Joint LhARA FETS FFA Meeting Mechanical Design

16/01/24

Simplified Vacuum Chamber

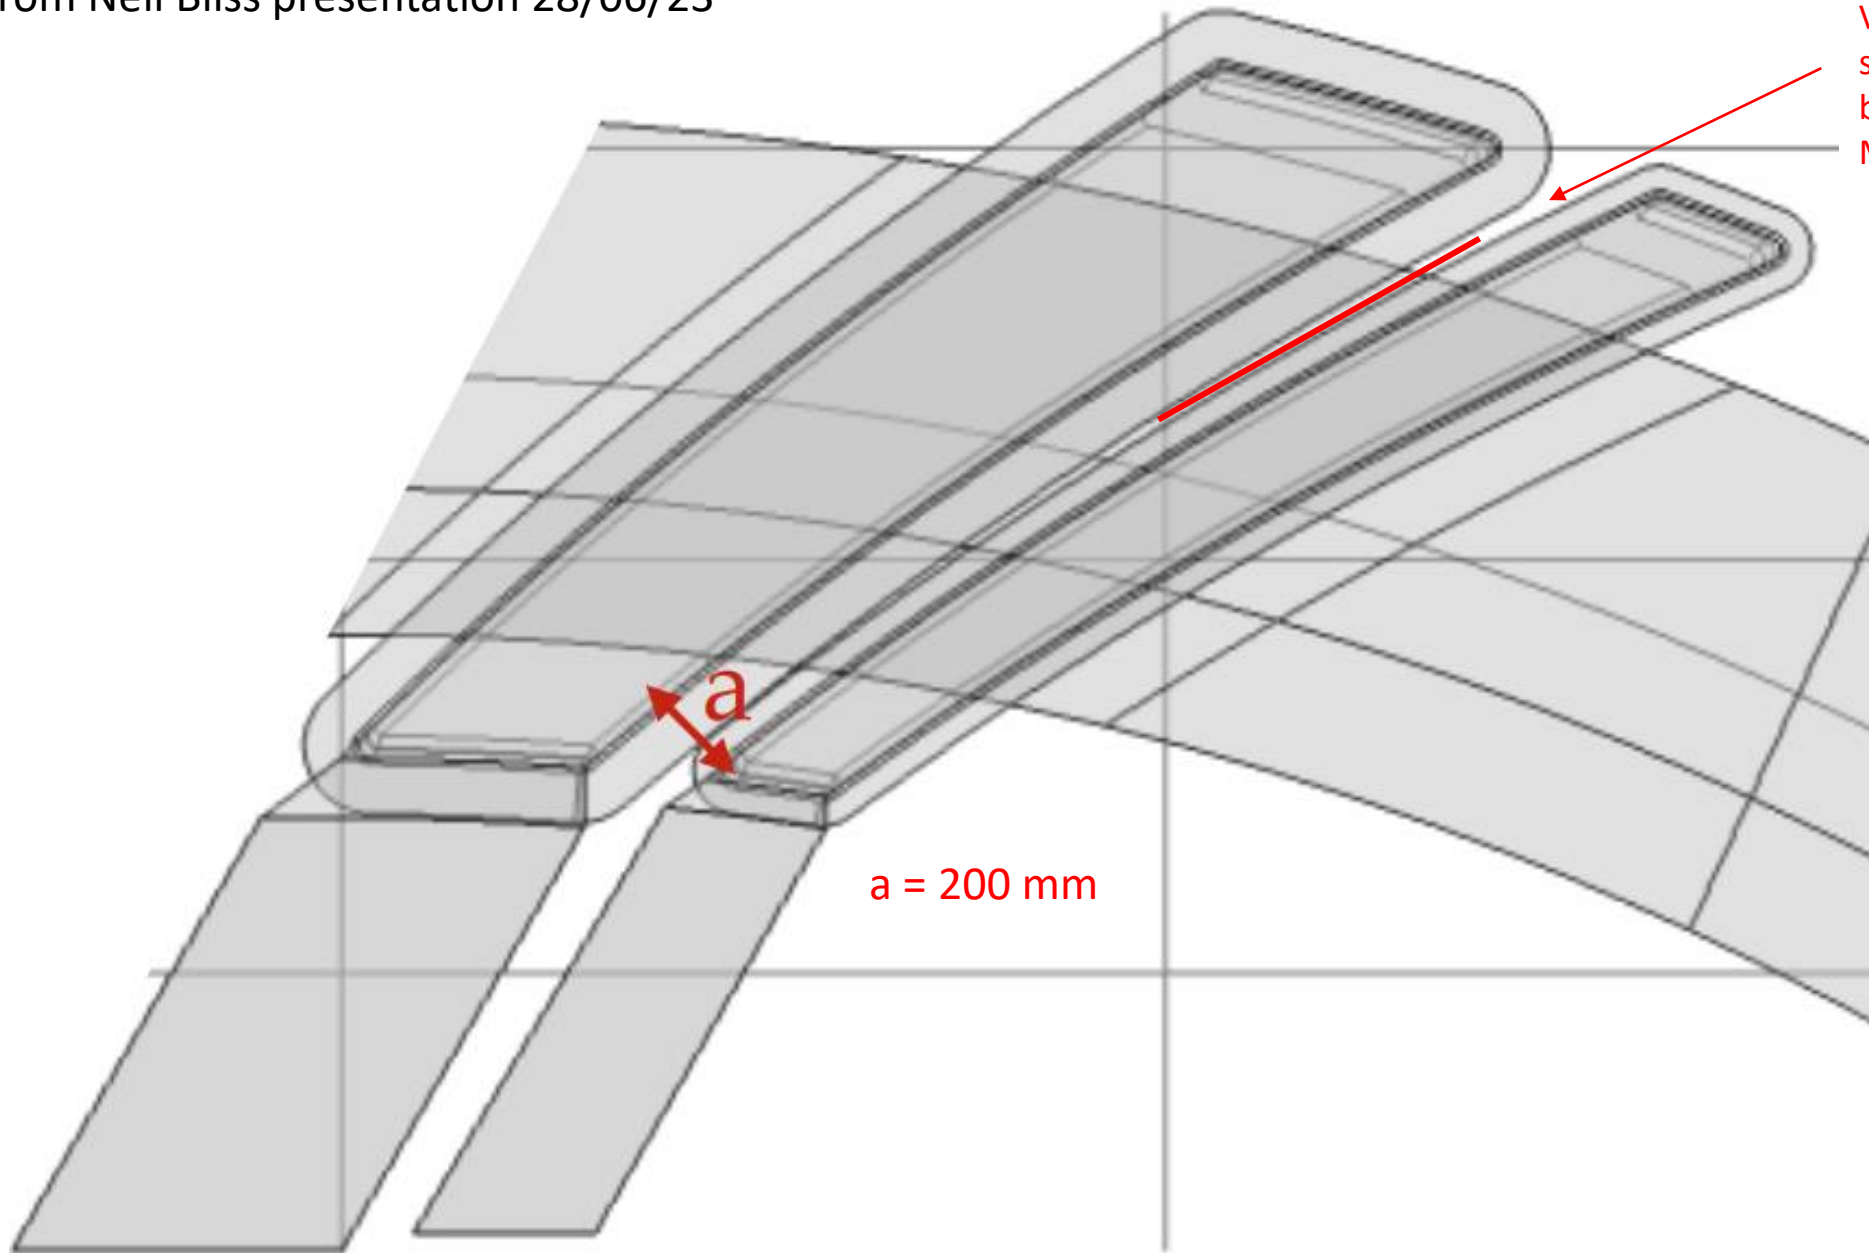
Vacuum chamber strengthening rib here between coils if practical? Maybe too small a gap!

G: 8mm - All Webs
 Safety Factor
 Type: Safety Factor
 Time: 1
 08/09/2023 11:42

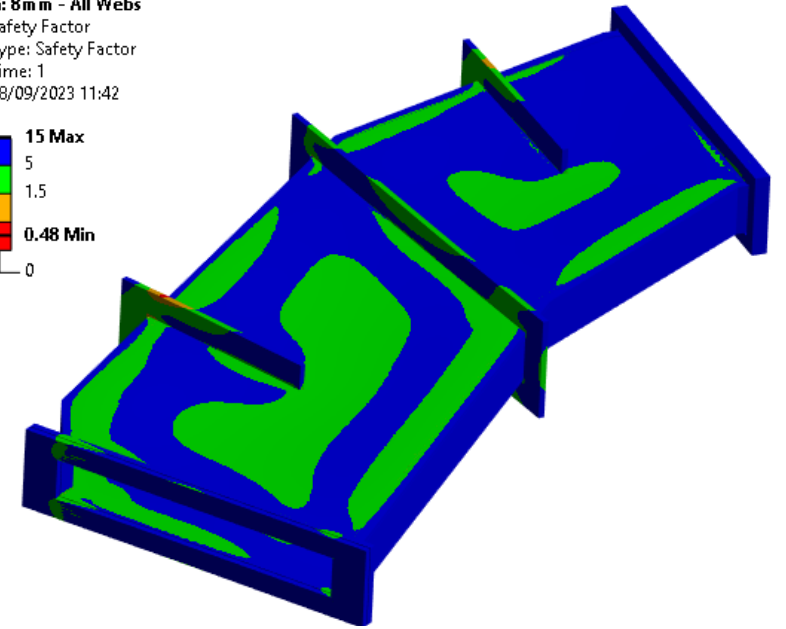
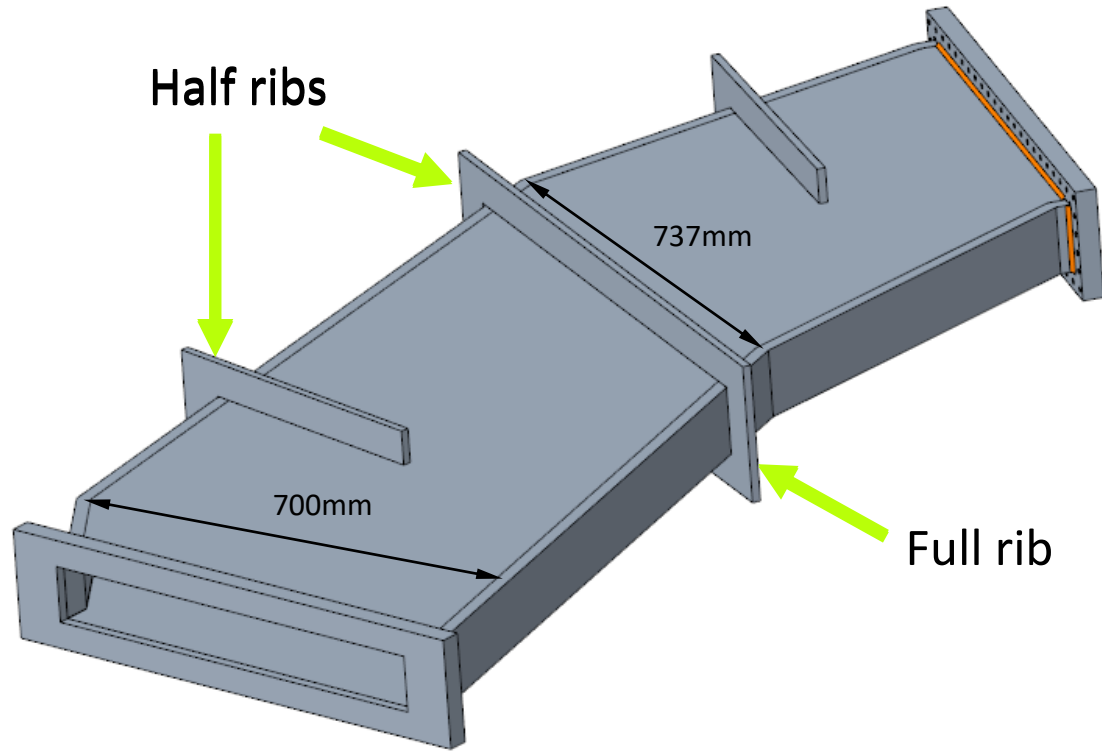
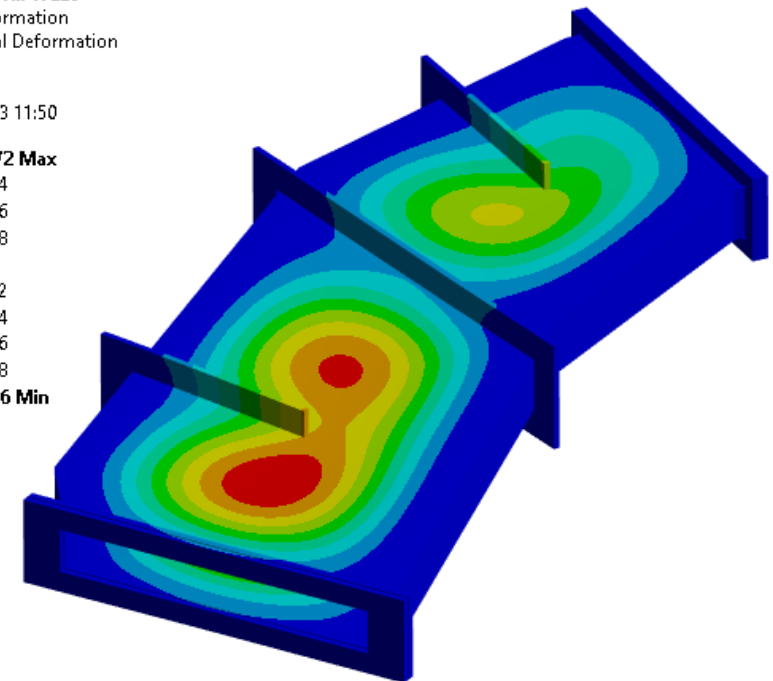
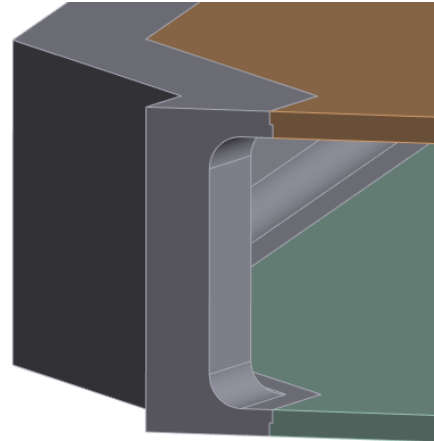
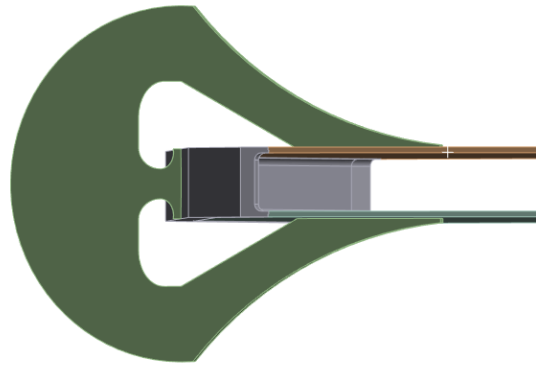
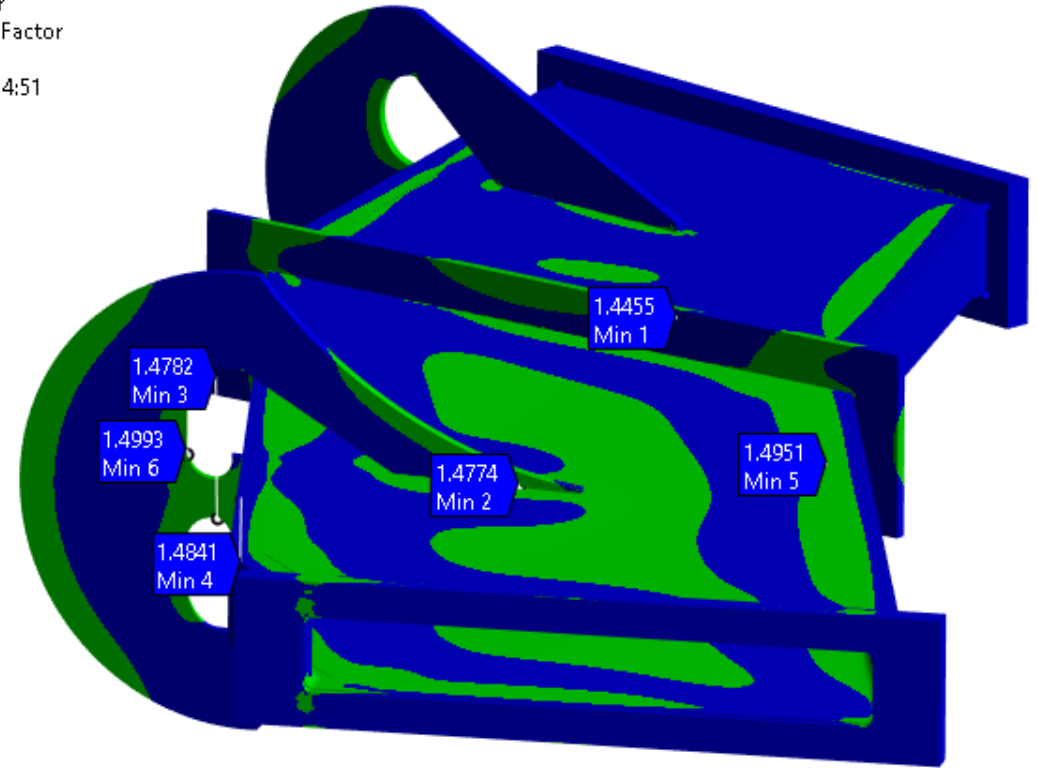
All Ribs			No Half Ribs			No Ribs		
	Max Deflection (mm)	Max Stress (MPa)	Max Yield/ Stress	Max Deflection (mm)	Max Stress (MPa)	Max Yield/ Stress	Max Deflection (mm)	Max Stress (MPa)	Max Yield/ Stress
6063 T6	7.23	5.38E+02	0.48	12.71	4.28E+02	0.61	12.94	6.67E+02	0.39
316LN	2.47	5.65E+02	0.45	4.40	4.31E+02	0.59	4.49	7.18E+02	0.35
Ti6Al4V	4.37	5.34E+02	1.58	7.61	4.28E+02	1.98	7.75	6.59E+02	1.28

Titanium and aluminium alloys are unsuitable due to their high deflections. 316LN is the only viable material of the three with the current geometry.

The original design is only suitable for the stress if made of Ti6Al4V.

Modifying the design to include rounds on the internal corners, and altering the shape of the ribs for stress relief, can achieve both the stress and deflection criteria
